# BOGGABRI COAL PROJECT - MODIFICATION

## Access Arrangements, Stockpiling and In-pit Fuel Storage (09\_0182 MOD 3)

**Figure 3: Vegetation Communities in the Modification Area**

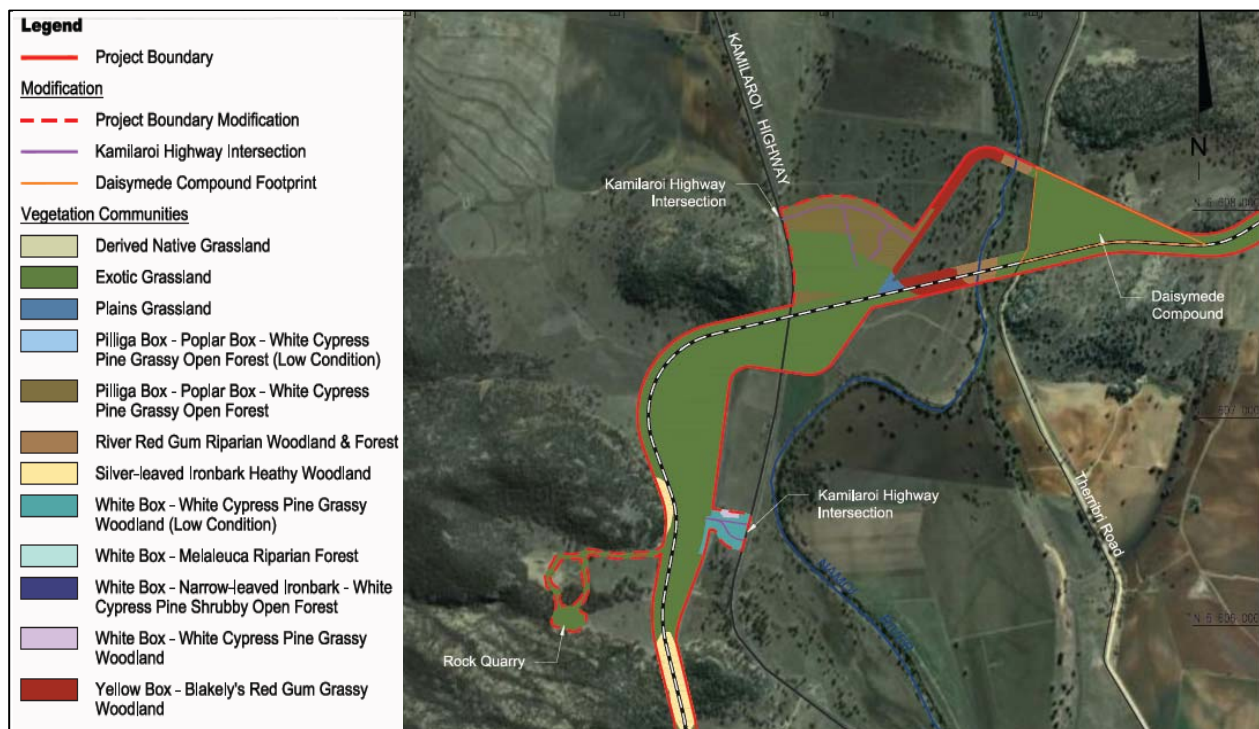
The Boggabri project application area and offset area were subject to flora and fauna surveys during the approval process for the Boggabri Coal project. Additional site specific surveys were also completed for each area to be impacted by the proposed modification. OEH raised concerns that a number of vegetation communities have been reclassified as a result of the more recent surveys, and that there are inconsistencies between the EA, the original project application and approved Biodiversity Management Plan for the project.

Boggabri Coal's ecological assessment indicates that approximately 48 ha of disturbance would occur to facilitate the modification, including 14 ha of native woodland in the areas proposed for the Kamilaroi Highway intersections and access routes (see **Figure 3**). Other aspects of the modification, including the use of the Rock Quarry and Daisymede Laydown Area, would not impact any native vegetation.

Two native vegetation communities would be impacted, including 11.2 ha of Pilliga Box – Poplar Box White Cypress Pine grassy open forest, and 2.8 ha of White Box – White Cypress Pine grassy woodland, which is listed as an Endangered Ecological Community (EEC)<sup>1</sup> under the *Threatened Species Conservation Act 1995* (TSC Act). The Box Gum Woodland EEC is reported to be in poor to moderate condition, while the majority of the Pilliga Box community is in moderate condition and dominated by native species. The majority of the disturbance (37.4 ha including 13.3 ha of native vegetation) would occur in an existing offset area for the Boggabri Coal Project, known as the Namoi River Offset. The Namoi River Offset area is approximately 2,469 ha in size and contributes to offsetting requirements for impacts to the Box Gum Woodland EEC. A summary of the impacts is provided in Table 1 below.

Notwithstanding, Boggabri Coal is proposing to provide offsets to compensate for the loss of 37.4 ha of the Namoi River Offset. In response to issues raised in submissions, Boggabri Coal has also committed to provide additional offsets to compensate for the impacts on the 14 ha of native vegetation at a ratio commensurate with EEC offsets for the Boggabri Coal Project (4.7:1). However, while Boggabri Coal has identified the need to offset the impacts from the modification, no specific offsets have been identified and therefore no detail on the location or condition of the offsets has been provided.

To this end, Planning and Infrastructure has recommended a condition which would require Boggabri Coal to provide a total offset of at least 103 ha, including a minimum of 16 ha of Box-Gum Woodland EEC and 63 ha of Pilliga Box Woodland to compensate for the loss of a portion of the Namoi River Offset and the additional impacts on native vegetation. This obligation would be in addition to the 1,000 ha already required under the project approval. Subject to the implementation of these offsetting measures, Planning and Infrastructure is satisfied that the proposed modification would be unlikely to result in any significant impacts on biodiversity.

**Figure 4: Privately-owned residences in the vicinity of the proposed modification**

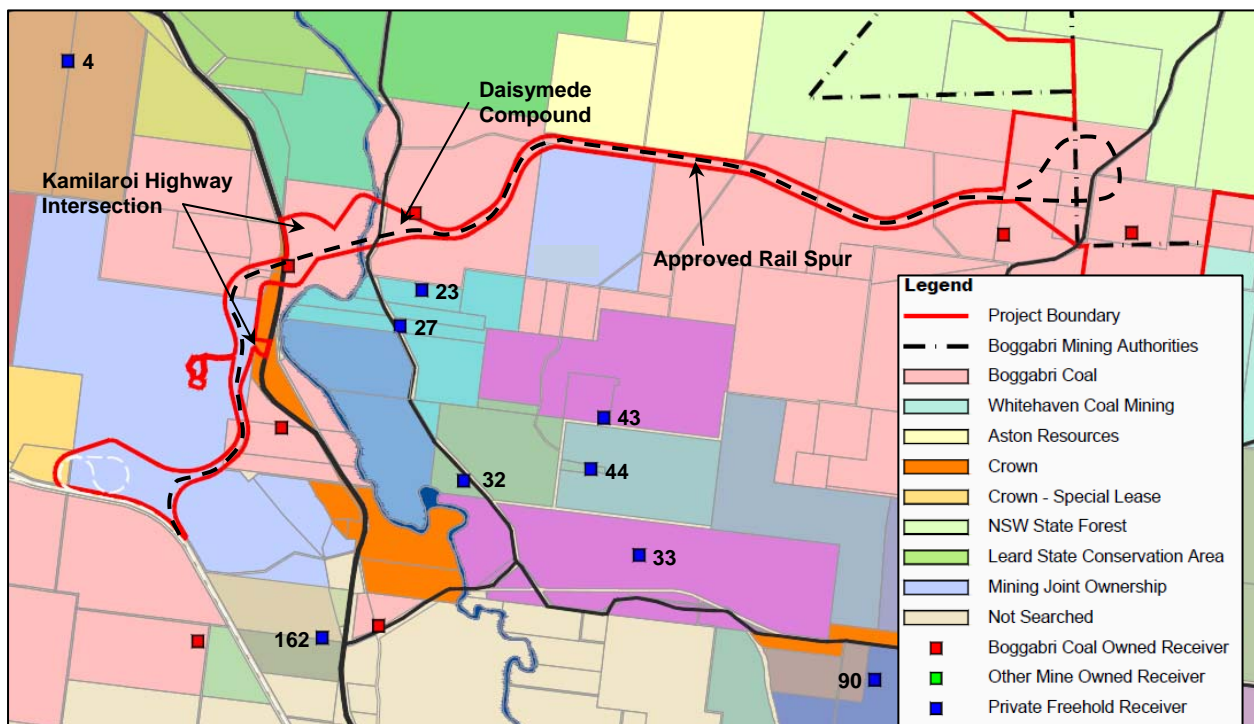
Construction noise levels would increase at 4 privately-owned residences (4, 23, 27, and 32) by up to 8dB(A) relative to the noise levels assessed and approved for the construction of the rail spur (see **Table 2**). Importantly, despite the predicted increase, the cumulative noise level generated by the access roads and rail spur line is predicted to remain at or below the applicable criteria in the project approval at all receivers. The locations of the receivers relative to the rail spur and proposed modification is shown in **Figure 4**.

Notwithstanding, Planning and Infrastructure notes that increased noise levels would occur during times when train noise coincides with traffic noise generated on the private haul road, particularly during these shift change periods. These increased noise levels would potentially result in additional impacts to receivers in close proximity to the haul road and rail spur (namely receivers 23 and 27).

Given these considerations, Planning and Infrastructure is satisfied that Boggabri Coal would be able to meet the construction noise criteria in the Boggabri Coal Project approval, and therefore the construction activities would be unlikely to result in any significant additional impacts on nearby receivers. Planning and Infrastructure has recommended a condition of approval requiring Boggabri Coal to comply with the rail spur construction criteria for all construction works associated with the Kamilaroi Highway access roads and Daisymede Laydown Compound.

Importantly, Boggabri Coal would be required to comply with the criteria in the project approval for all activities including the proposed modification. In the event that Boggabri Coal cannot comply, they will be required to implement the above mitigation measures to reduce impacts on privately owned receivers. It is also important to note that any potentially affected residences (such as 23 and 27) already have acquisition rights under the existing approval. If the landowners choose not to exercise these rights, they may also request noise mitigation measures be applied at their residences.
